Appeal by Hallam Land Management Ltd
Land North of A507, West of A10, Buntingford

Highways Statement of Common Ground between
Hertfordshire County Council as Highway Authority
and
East Hertfordshire District Council as Local Planning Authority
and
Hallam Land Management
June 2026

Report Ref: HCC-Ridge-Tt-HSoCG

LAND NORTH OF A507 AND WEST OF BUNTINGFORD: HIGHWAY ACCESS

PROJECT REF:	STATUS:
23161	N/A
DRAWING No:	REV:
032	P1

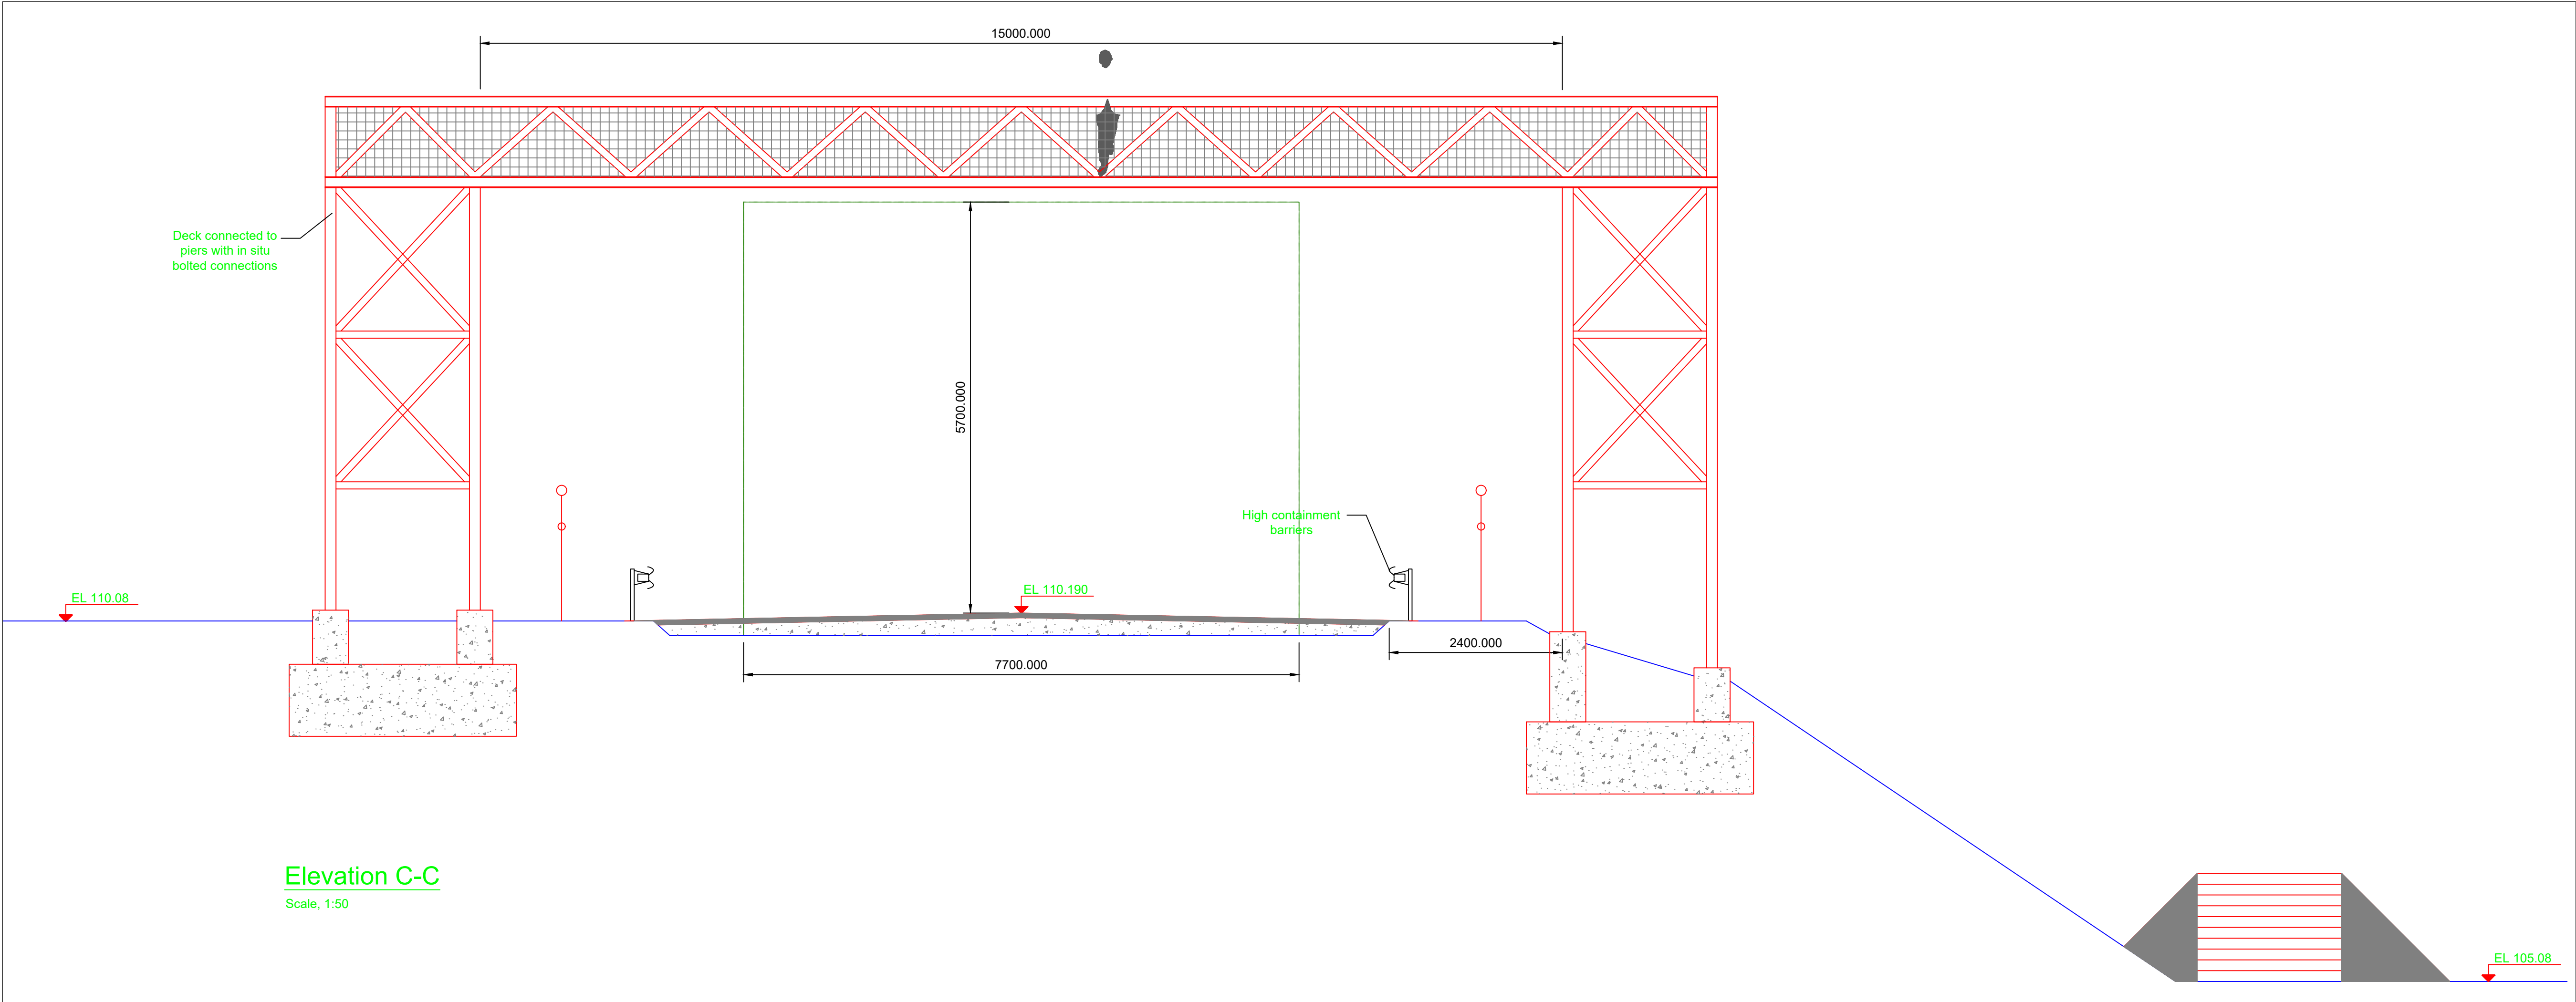
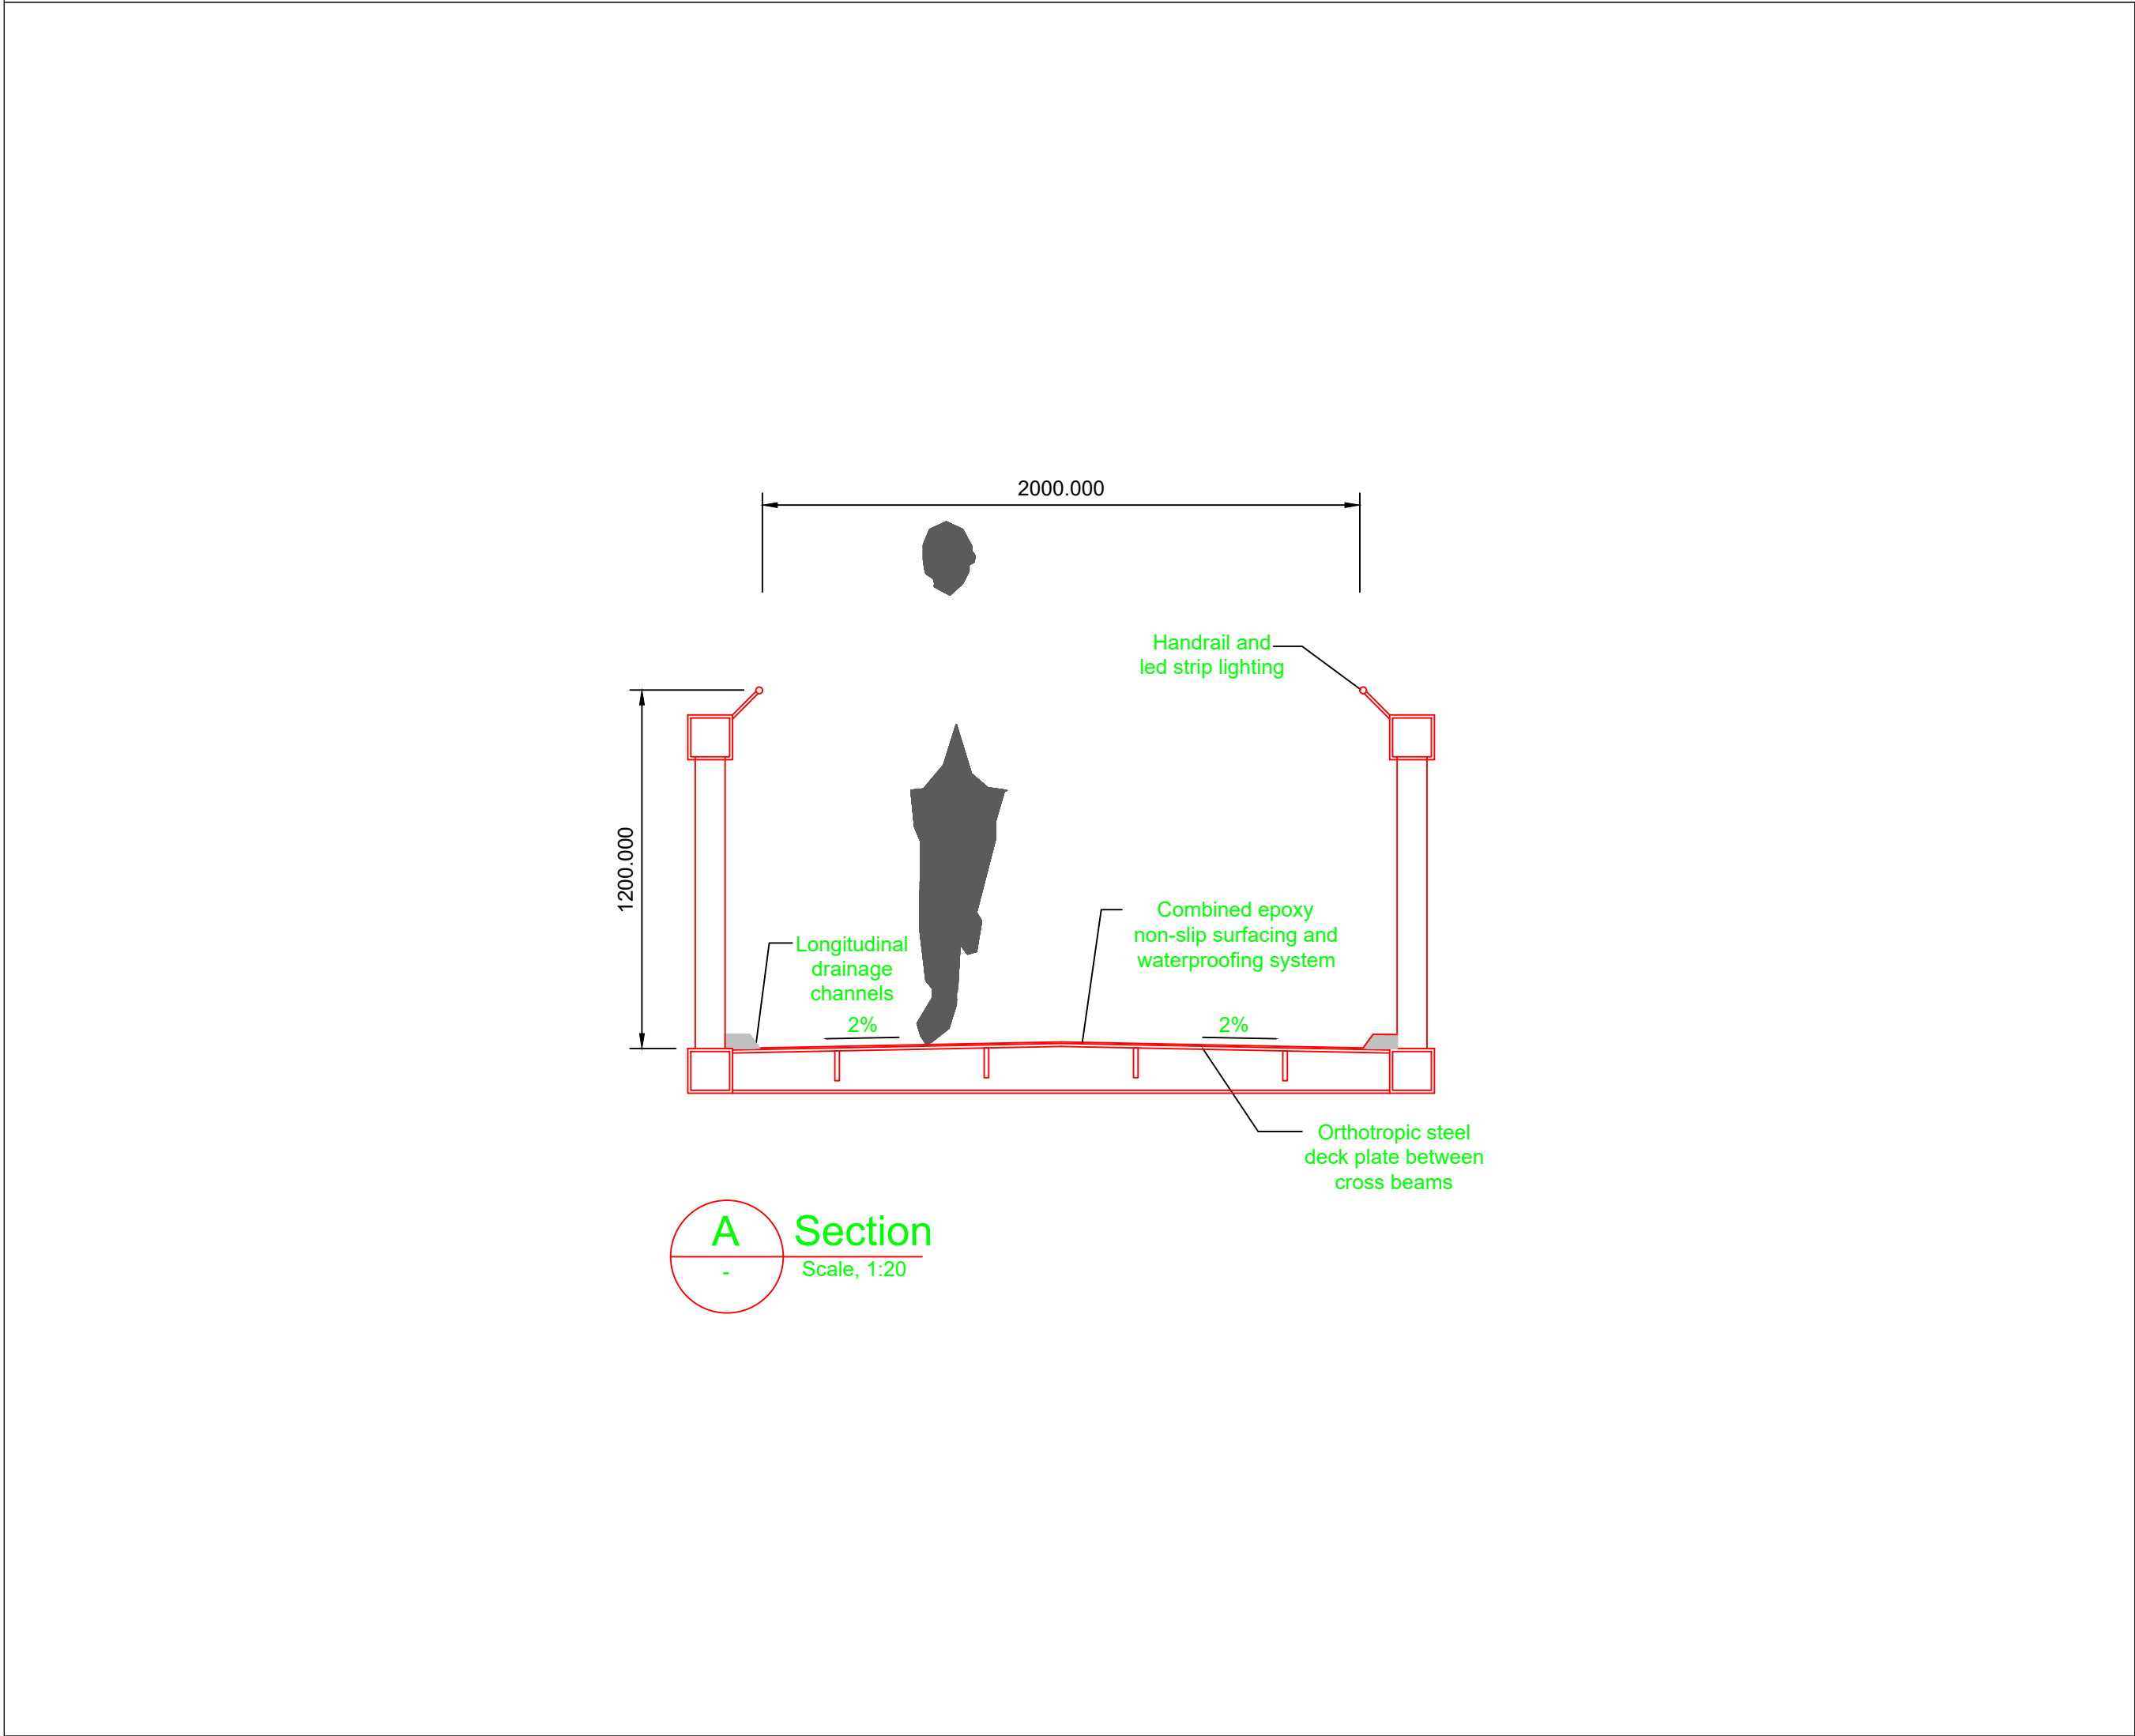
Drawing 23161 – 032 Rev P1

- 2.11 After due and careful consideration the audit team have been unable to identify any areas of concern in terms of highway road safety associated with the information portrayed on this drawing for this stage of road safety audit. See Also Comment 3.2

- 3.1 One of the drawing numbers is illogical and it has been assumed that this is a drafting mistake and will be rectified as the scheme progresses.
- 3.2 The highway authority has requested that the introduction of a Toucan Crossing for the southbound approach to the Baldock Road roundabout junction be considered in terms of safe operation. The audit team's observations are listed below, all carrying equal significance and are in no particular order.
